A G E N D A
JAMES CITY COUNTY DEVELOPMENT REVIEW COMMITTEE
REGULAR MEETING
Building A Large Conference Room
101 Mounts Bay Road, Williamsburg, VA 23185
August 23, 2017
4:00 PM

CONCEPTUAL PLAN-0058-2017. Norge Food Lion Store - Enclosed Dumpsters Addition

Staff Report for the August 23, 2017, Development Review Committee

Proposed location of enclosed dumpsters

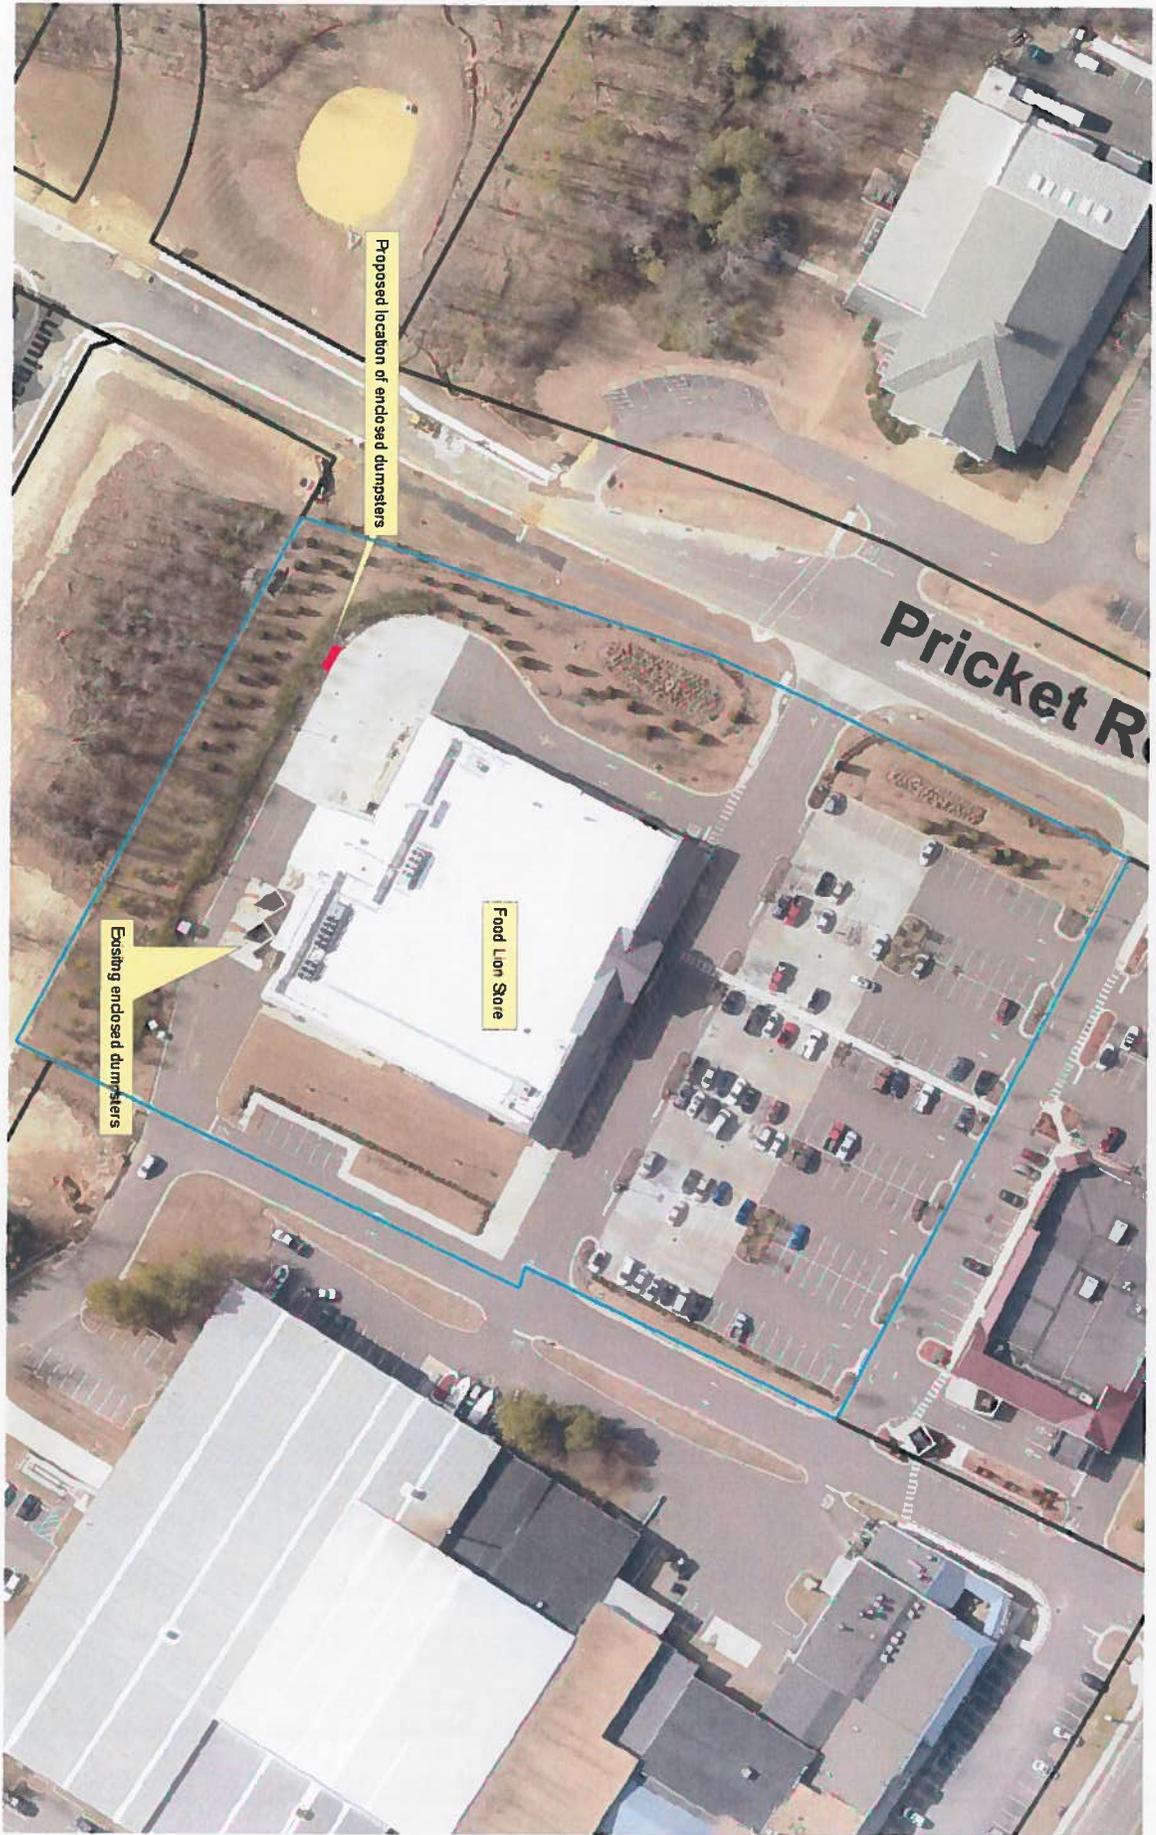
LOOKS LIKE
 SMALL
 WATER
 COLLECTION
 AREA

POTENTIAL
 NEW DUMPSTER
 ENCLOSURE LOCATION

- HAVE TO FILL SLOPE OR BUILD ~~BACK~~ WALLS AS A RETAINING WALL.
- HAVE TO RELOCATE ALL DISTURBED TREES & SHRUBS.
- HAVE TO QUALIFY THAT ADDED IMPERVIOUS AREA DOES NOT GO OVER ALLOWABLE IMPERVIOUS AREA.
